Submission of Further Information (FI)

**Temporary Animal Boarding Establishment with Ancillary Facilities
for a Period of 5 Years and Associated Filling of Land in “Agriculture” Zone,
Lot Nos. 1493 (Part) and 1500 (Part) in D. D. 107 and Adjoining Government Land,
Kam Tin, Yuen Long, New Territories
(Application No. A/YL-KTN/1061)**

Further Information for Planning Application No. A/YL-KTN/1061

Comments from the Drainage Services Department

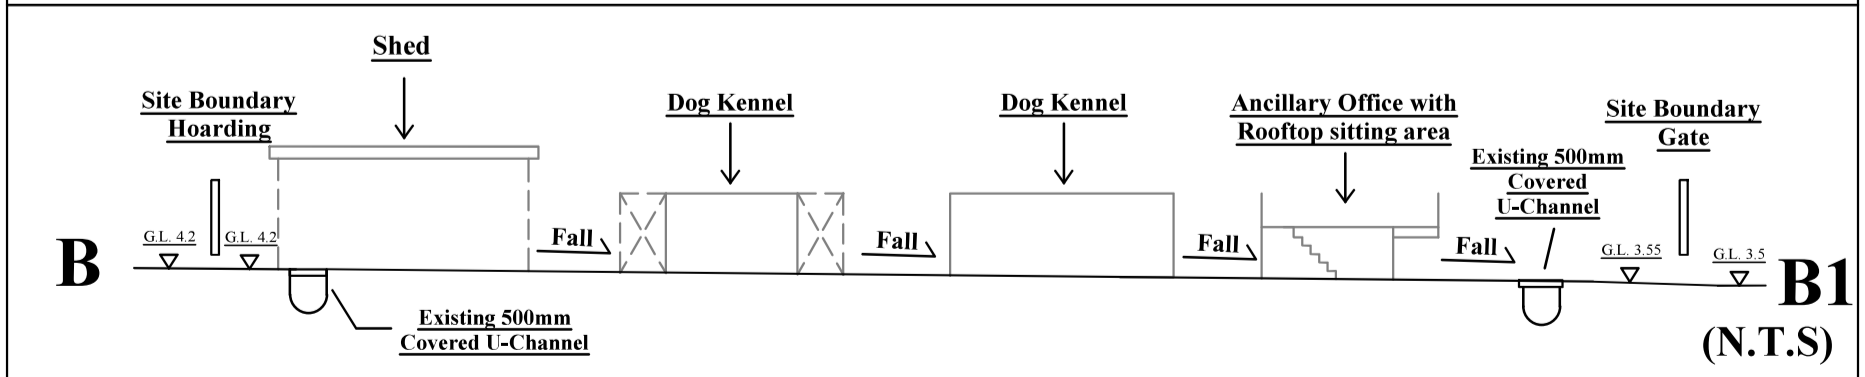
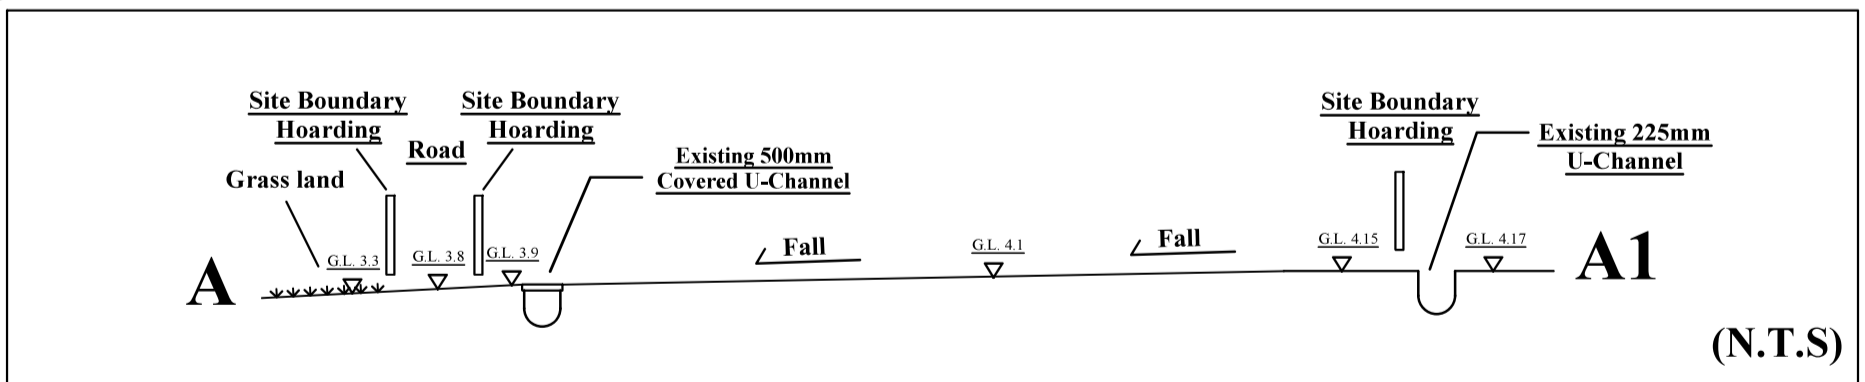
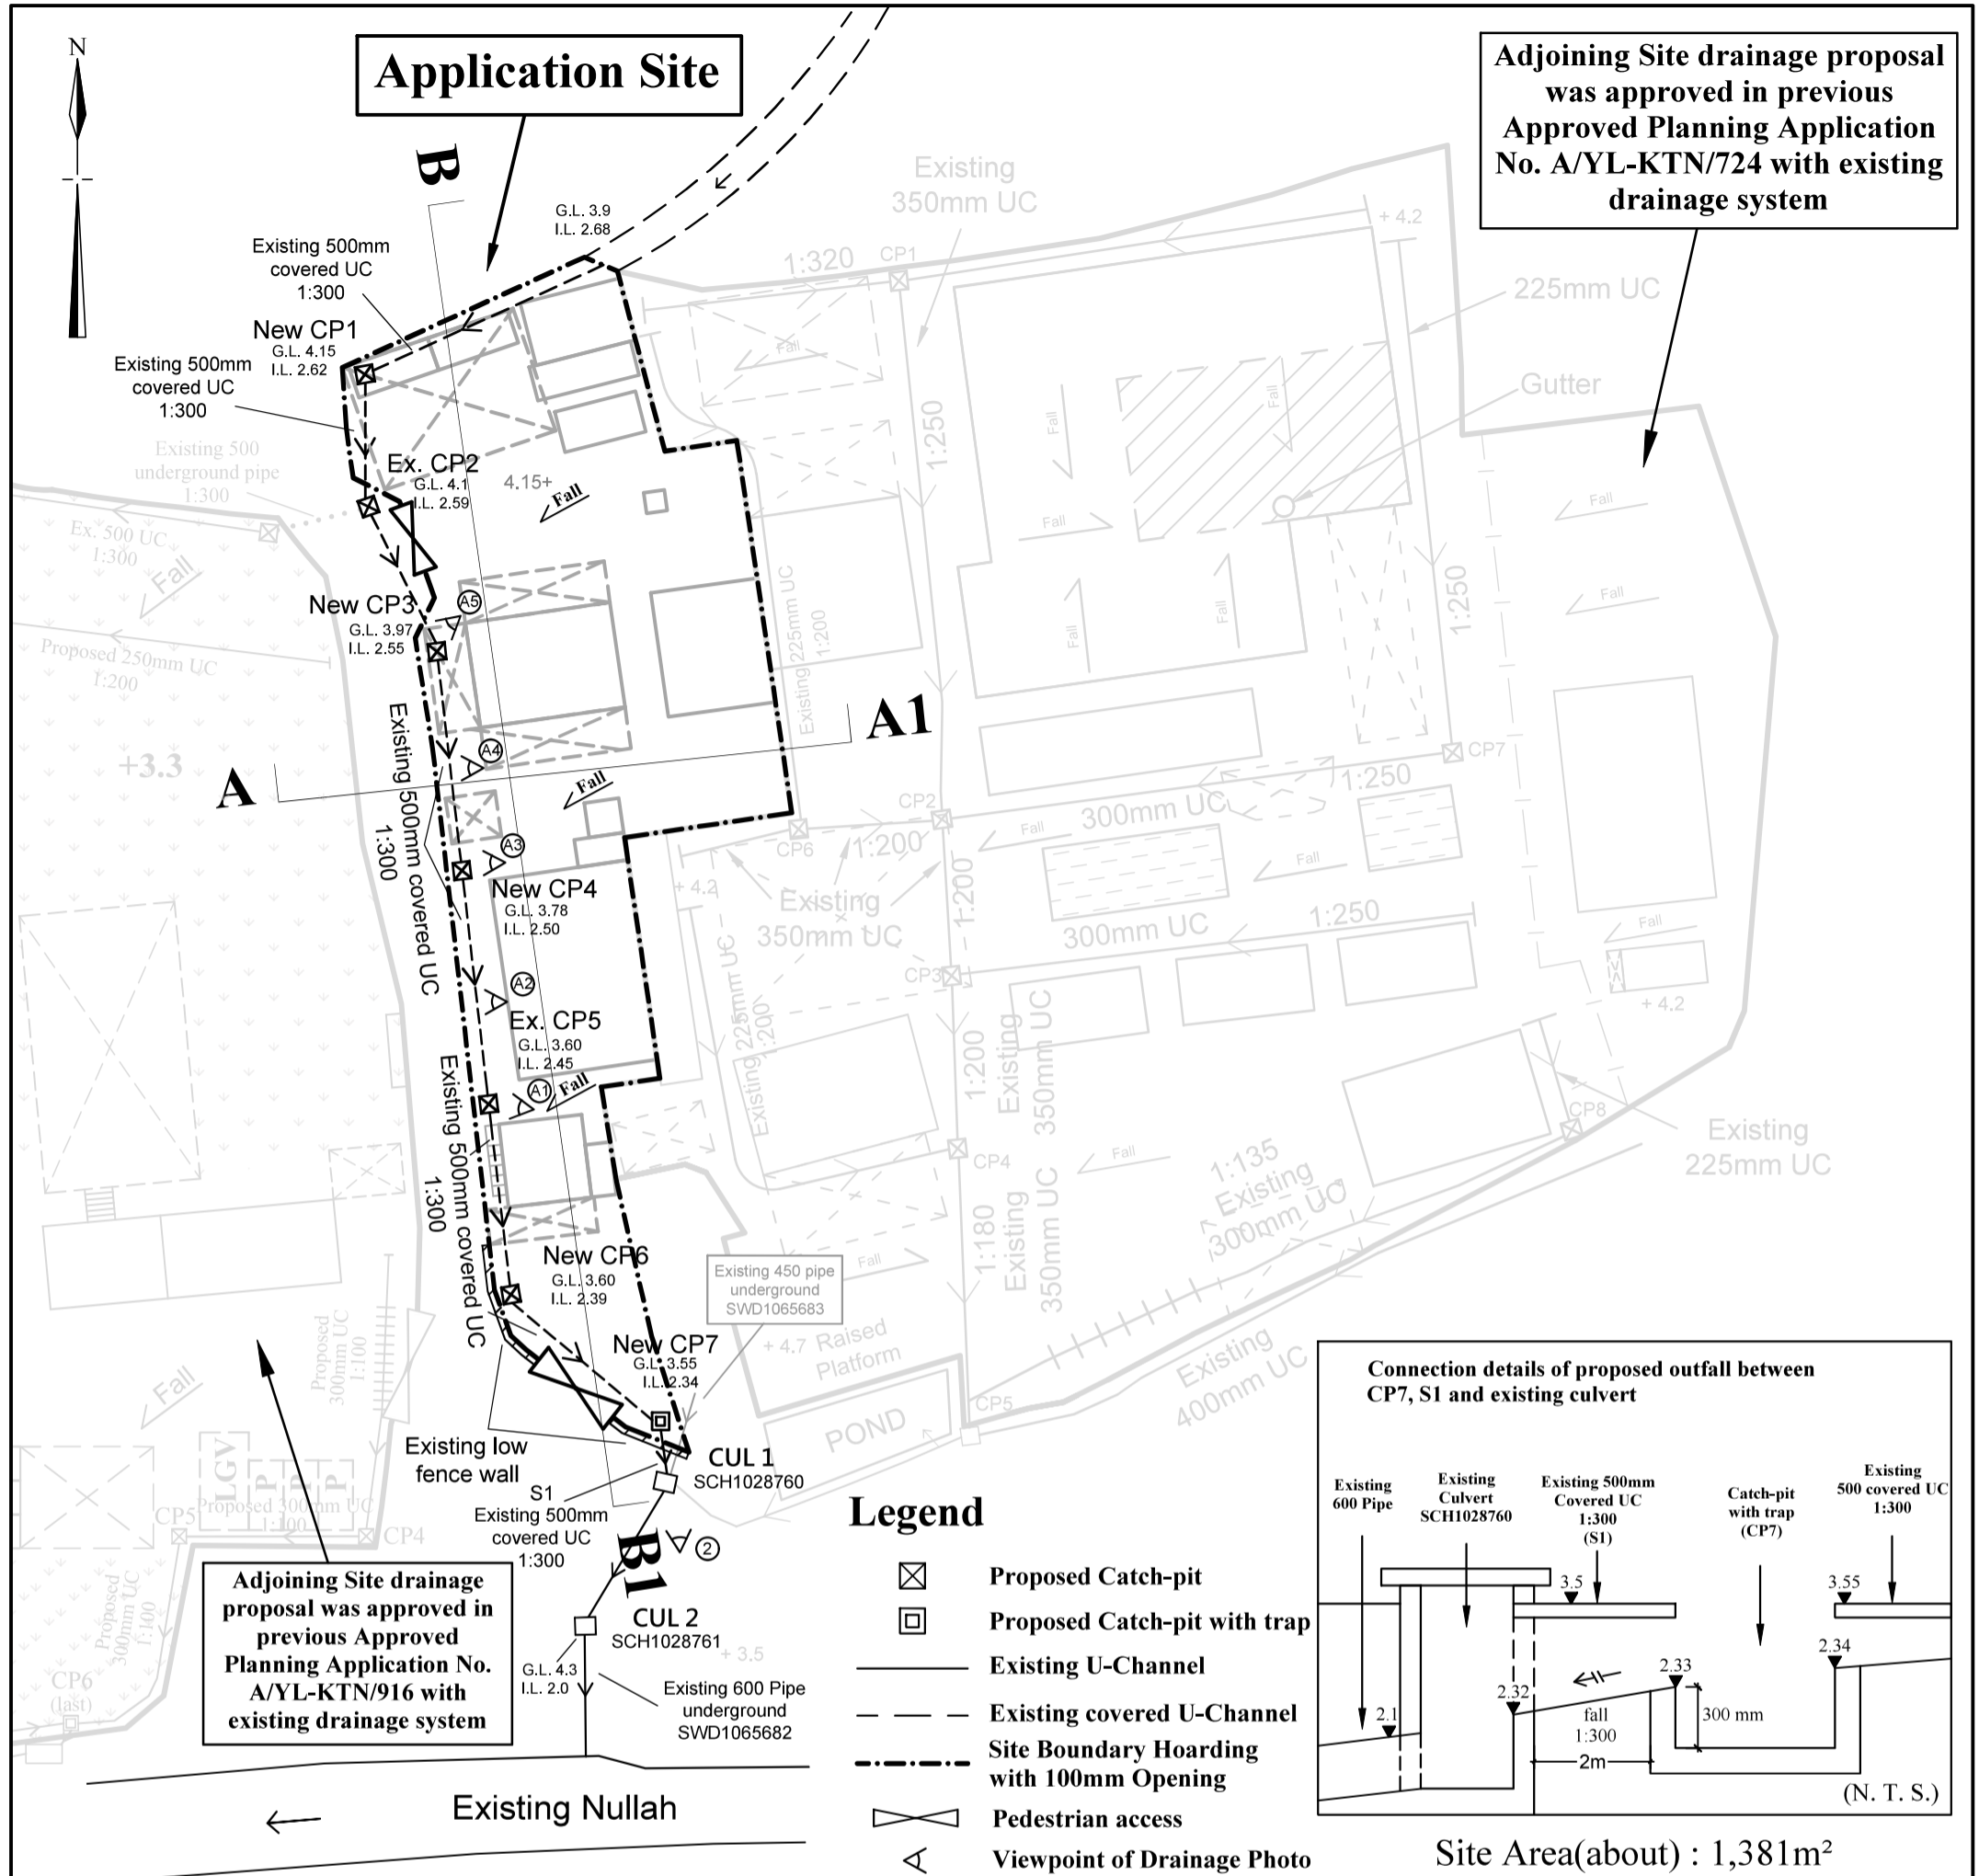
(vii)	Please advise why u-channel is not provided at the eastern side of the site. Please advise how the overland flow from the above area of the site could be properly intercepted and discharged. Peripheral surface channels shall be provided along the site boundary to collect the surface runoff accrued on the application site and to intercept the overland flow from the adjacent lands.	The ground level at the eastern side of the site is higher than the western side. The surface run-off flows from the east to the west. Please refer to cross-section for details.
(viii)	The applicant should check and ensure the hydraulic capacity of the existing drainage facilities would not be adversely affected by the captioned development. Please provide site photos to show existing condition and existence of the existing drainage facilities which receive the discharge from the application site.	Noted. Please refer to enclosed site photos for details.

Plan 5.1a (P 23044)

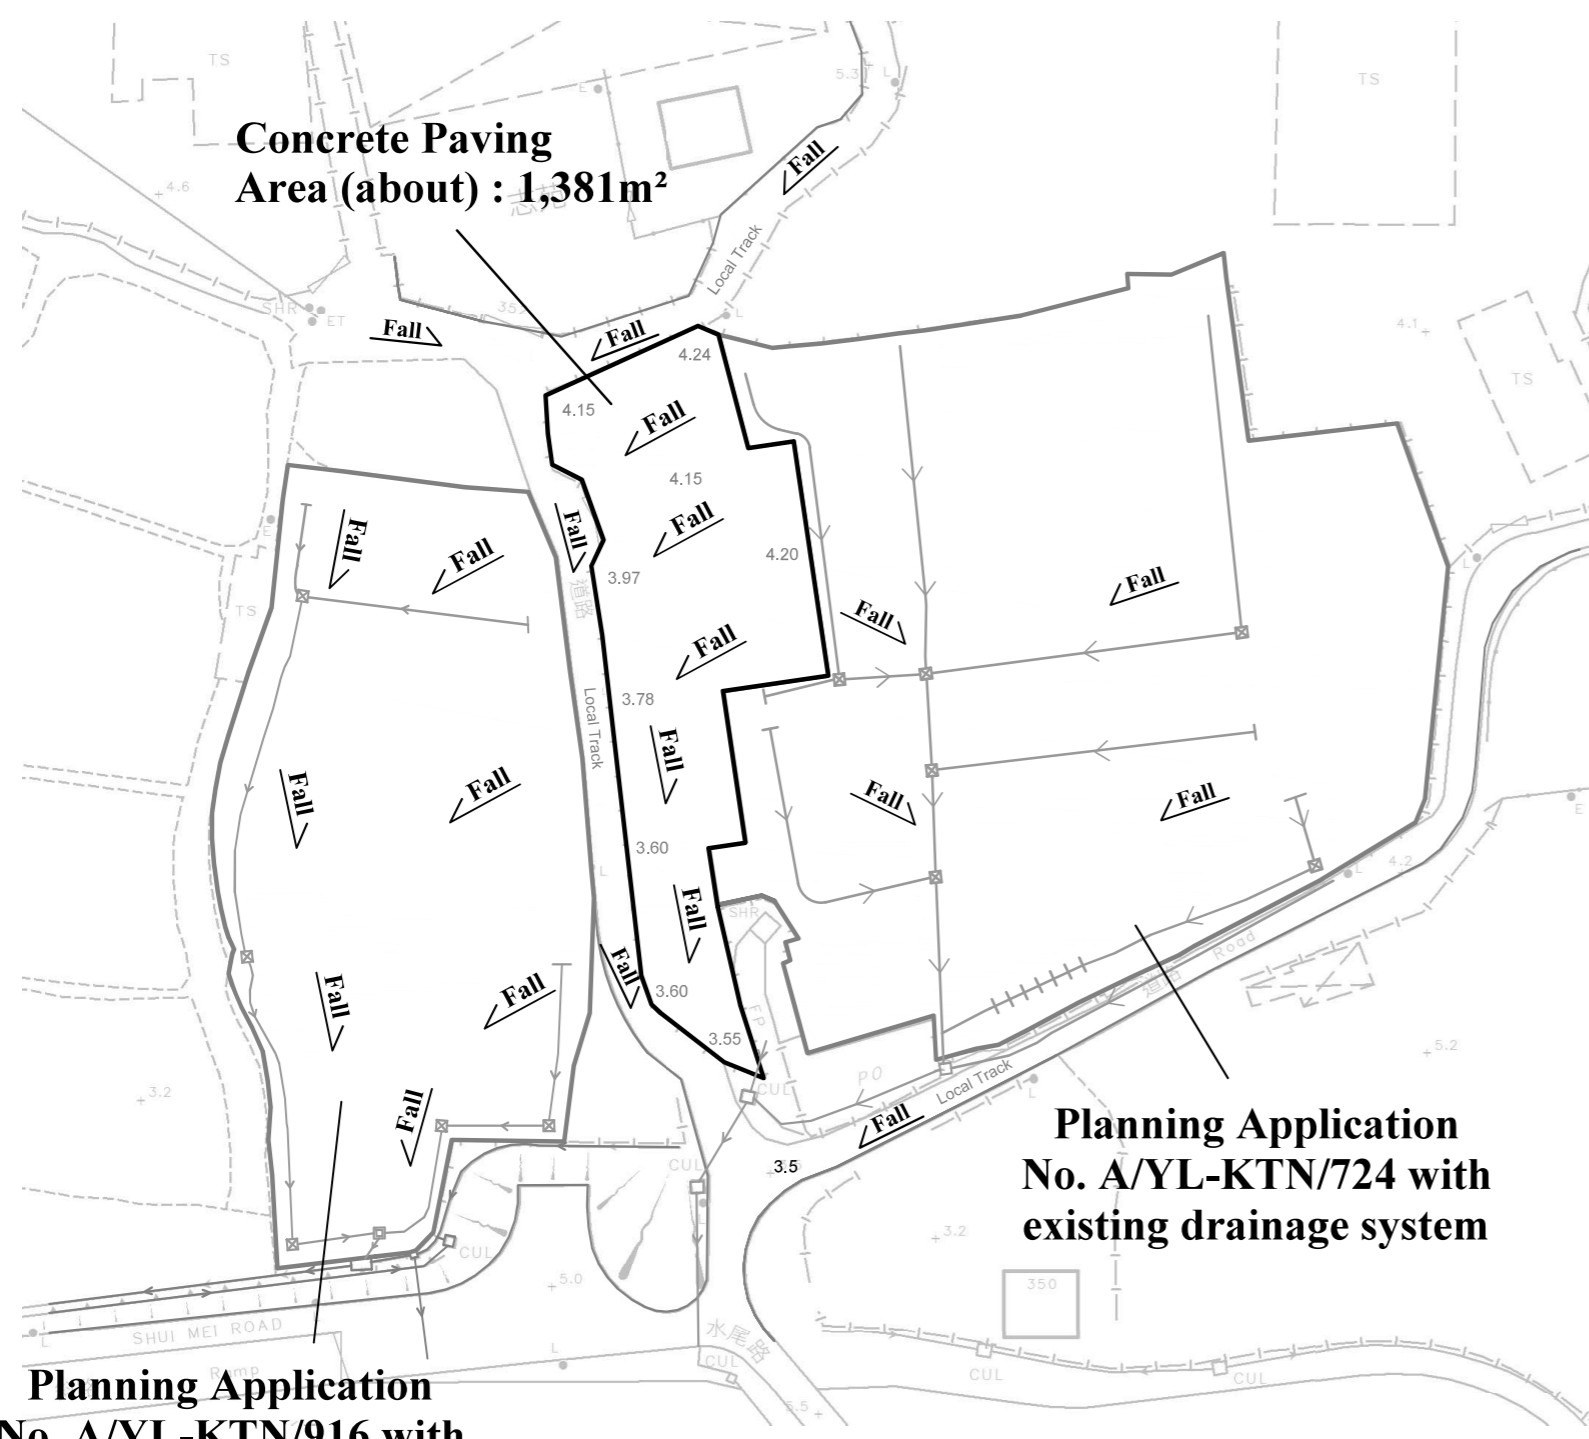
(v)	Please demonstrate with hydraulic calculations, with catchment plan, that all proposed/existing drainage facilities are adequate to collect, convey and discharge the surface runoff accrued on the application site and to intercept the overland flow from the adjacent lands.	Please refer to the hydraulic calculations for details.
(vi)	Please submit calculation demonstrating the downstream drainage system receiving the discharge from the development has adequate spare capacity to accommodate the runoff.	Please refer to the hydraulic calculations for details.

**Plan 5.2a
(P 23044)**

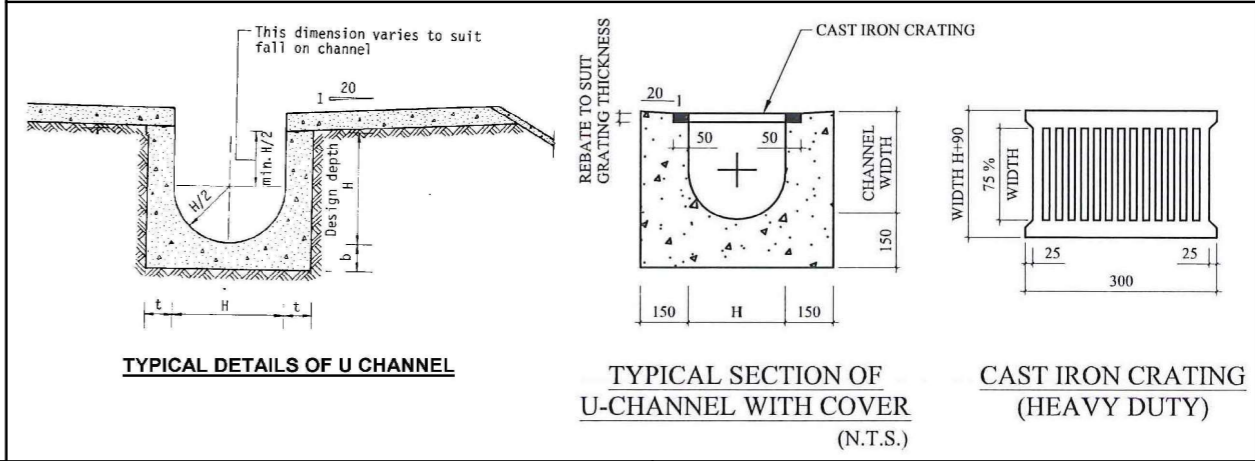
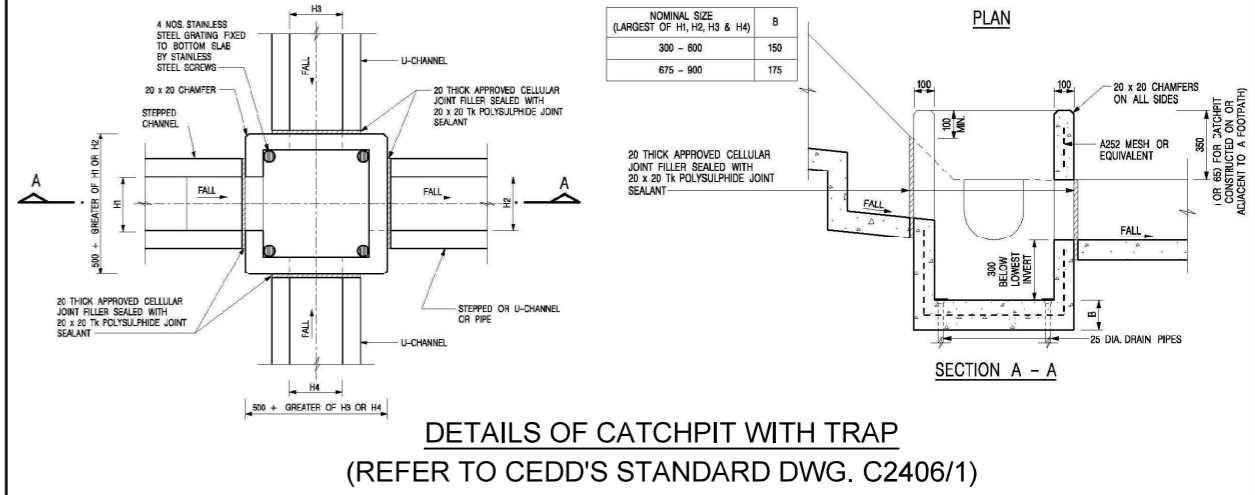
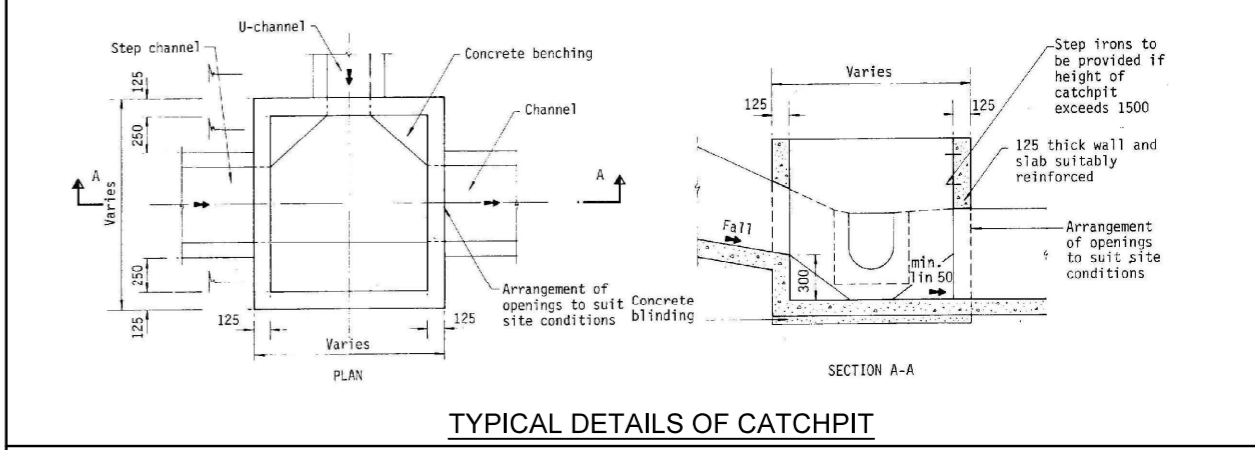
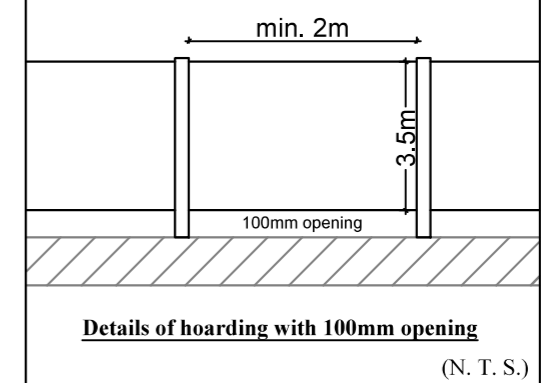
(ix)	Please clarify whether any walls or hoarding would be erected along the site boundary. Where walls or hoarding are erected/ laid along the site boundary, adequate opening should be provided to intercept the existing overland flow passing through the site.	Hoarding with openings will be provided along the site boundary. Please refer to Plan 5.2a for the details of hoardings.
